VERBAL APPROVAL TO RIG SKID FOR GARDNER

From: Andrews, David
Sent: Tuesday, May 15, 2012 3:46 PM
To: 'Reynolds, Scott D.'
Cc: Kerr, Thom; Ellsworth, Stuart; King, Kevin; Abell, Matt; Croteau, Jevin; Stanczyk, Jane; Westerdale, Barbara
Subject: RE: Parachute PC28 Pad Operations
Attachments: PC28 5 new coductors.pdf; PC28 pad data.doc; Statewide Lost Hole Rig Skid Approval Reporting_03-16-2012.pdf

28-23DD
 SAVED TO WELL FILE FOR GARDNER
 28-3B
 045-21193

If everyone isn't thoroughly confused by now, the following diagram may or may not help!

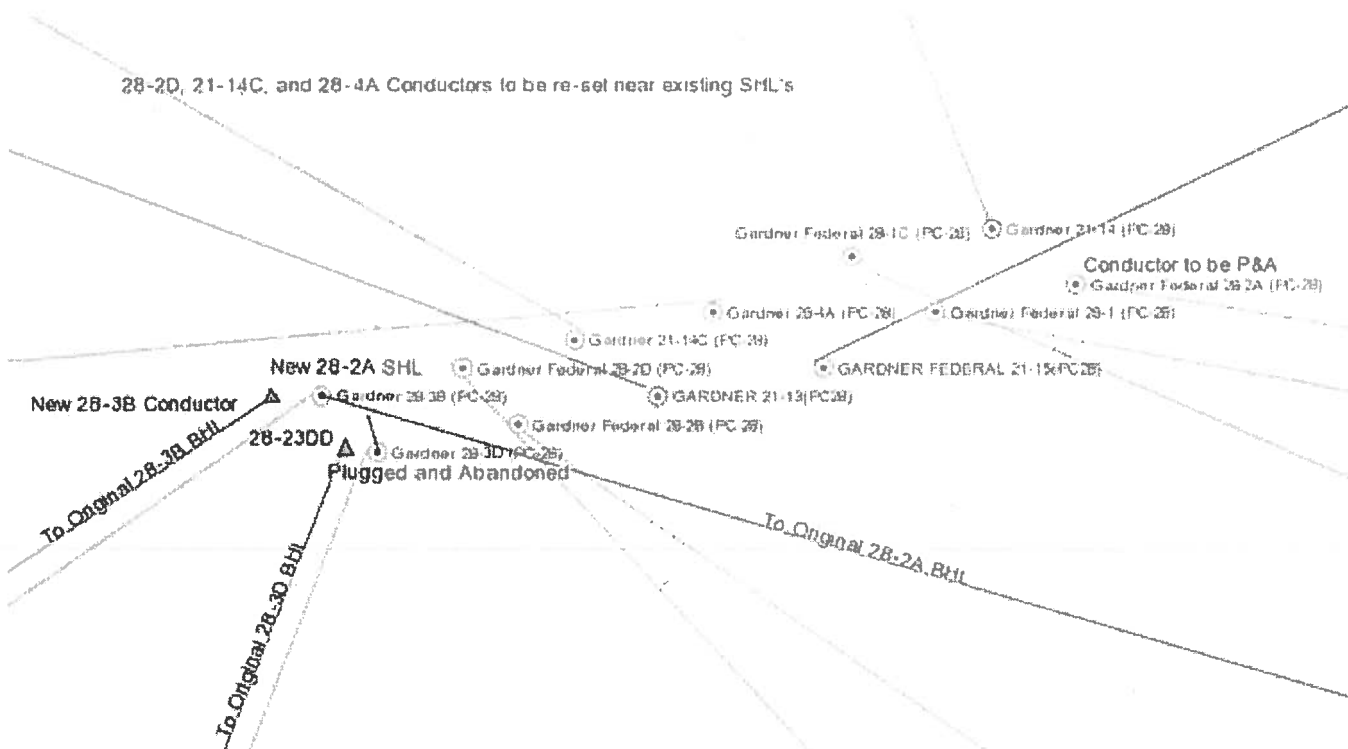
Gardner 28-23DD: New well resulting from a rig skid to a new conductor 16.5' west of the plugged and abandoned Gardner 28-3D well. This email acknowledges my verbal approval to proceed with the rig skid. A new **Form 2 (Application for Permit to Drill)** will be required in addition to the other submittals requested by Kevin King for the Gardner 28-3D plugging and abandonment (summarized above) and required by the attached Rig Skid guidance document. I understand that the Gardner 28-23DD BHL will be the same BHL that was originally planned for the Gardner 28-3D well and that BHL is not located in the Rulison Tier II zone.

Gardner 21-14C: Submit a **Form 4 (Sundry Notice)** that describes the plugging of the existing conductor pipe, the plan to set a new, deeper conductor pipe, the change of the SHL, the new directional survey to account for the new SHL, and as-drilled GPS data for the conductor that is plugged and abandoned.

Gardner 28-4A: Submit a **Form 4 (Sundry Notice)** that describes the plugging of the existing conductor pipe, the plan to set a new, deeper conductor pipe, the change of the SHL, the new directional survey to account for the new SHL, and as-drilled GPS data for the conductor that is plugged and abandoned.

Gardner Federal 28-2D: Submit a **Form 4 (Sundry Notice)** that describes the plugging of the existing conductor pipe, the plan to set a new, deeper conductor pipe, the change of the SHL, the new directional survey to account for the new SHL, and as-drilled GPS data for the conductor that is plugged and abandoned.

Gardner 28-3B: Submit a **Form 4 (Sundry Notice)** that describes the change of the SHL and the new directional survey to account for the new SHL. I understand that the Gardner 28-3B BHL will be the same BHL that was originally planned for the Gardner 28-3B well and that BHL is not located in the Rulison Tier II zone.
